2NSW-106
Instrument Room Ventilation
Unit 3 Supply Line

INDIANA & MICHIGAN ELECTRIC CO.
DONALD C. COOK NUCLEAR PLANT

CONTAIN. VICINITY
DWG. NO. 2-NSW-106
REV. 7

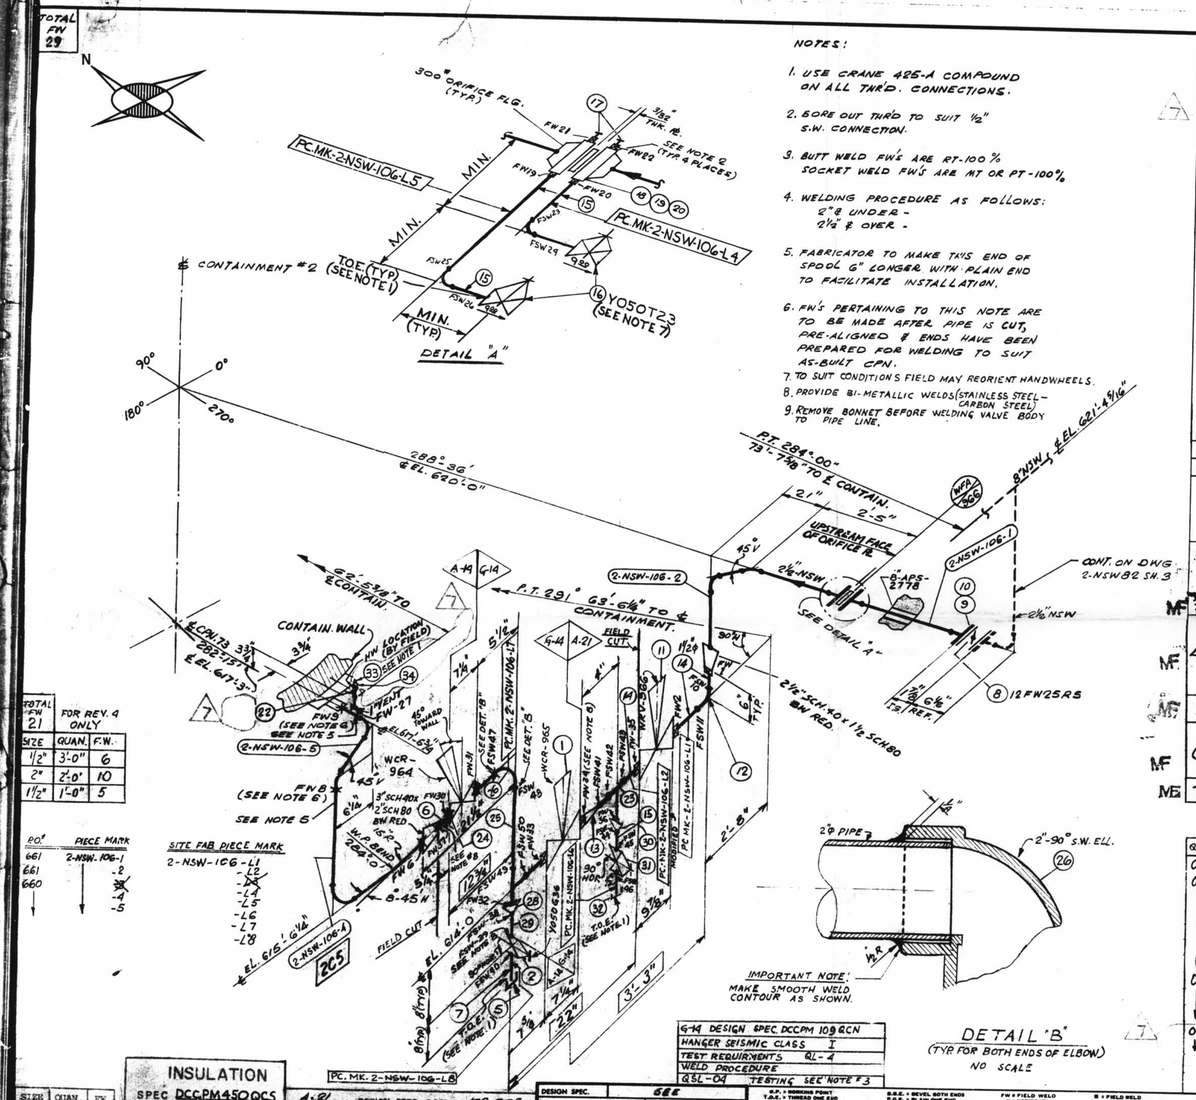
NO.	DATE	DRN CHK.	DESCRIPTION	REMARKS
1	7-8-74	JM.	REMOVED HOLDS ON PC.MK-2-NSW-106-L4 & L5 ADDED ITEM #21 ON B/M, INSULATION STAMP PO.#660 & 661, NOTE #7, & QUANTITY CHANGE ON ITEM #15 ON B/M. PER A.E.P. ARRG'T DWG. 2-5567C-1	FIELD ACTION REQ'D
2	12-20-76	P.G.A. B.R.	REVISED BY AEP DESIGN: PER RFC-12-671: REV'D: ITEM #2 Y-050G36 WAS CY-050G36. ADDED: 1" VENT - VALVE N2 Y-100T23, 2" CHECK VALVE Y-200C36	ACTION REQ'D.
3	12-7-78	D.W.K.	CHANGED VA. NO. TO Y200C36 WAS T36.	
4	7-19-81	K.A. D.R.	PER RFC#DC-12-2549 REPLACED ISOL. VA'S WCR-964 & WCR-965 WITH DIAPH. CONTROL VA'S WCR-964 & 965 ADDED: PIPE SPEC. G-14, DIM'S, WELD BOX, FW 30-37, FSW 38-50 ITEM N2'S 23 THRU 32 TO B/M NOTES 8 & 9 PC.MK.2-NSW-106-L6, 174 LB. DELETED ITEM N2 3, 4 & 21 FROM B/M, PC.MK.2-NSW-106-L3 & PC.MK.2-NSW-106-L3, REV. ITEM N21 IN B/M, MODIFIED PC.MK.2-NSW-106-L2.	FIELD ACTION REQ'D.
5	7-23-81	K.A. L.B.	PER RFC#DC-12-2549 ROTATED ACTUATOR OF VALVE WCR-964 TO 15° VERT. FROM CONTAINMENT WALL.	FIELD ACTION REQ'D

6	6/1/82	K.A. M.E. E.G.	PER RFC-DC-12-2549 REVISED ORIENTATION OF WCR-964, BOXED DIMENSION'S INDICATE FIELD INFO. DIMS. 3/8" WAS 7 7/16, 3/4" WAS 3 3/8 & 4" WAS 6 1/4. ITEMS 25 & 27 WERE SCH. 80 PIPE, ADDED DET. "B" & ADDED 1" PLUG TO ITEM 22 & 24.	FIELD ACTION REQ'D
7	4/26/84	WT J.M.	PER RFC-DC-12-2549 ADDED PLUG, ITEM 33, & RED. INSERT, ITEM 34, TO VALVE, ITEM 22, WHICH WAS Y-100T23.	NO ACTION REQ'D.
